# Addendum No. 1

City of Coquitlam
Tender No. 51772
Atlantic Ave Road Rehabilitation and Curb Extensions

**Issue Date:** March 14, 2024 (Consists of 3 Pages)

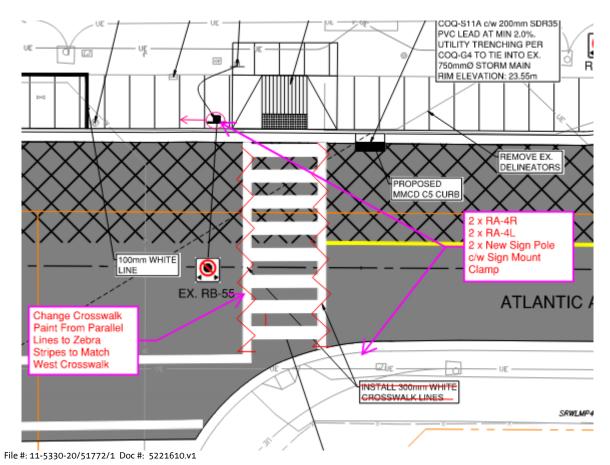
Note: Changes have been made to signage and thermoplastic pavement markings. See sketch below:
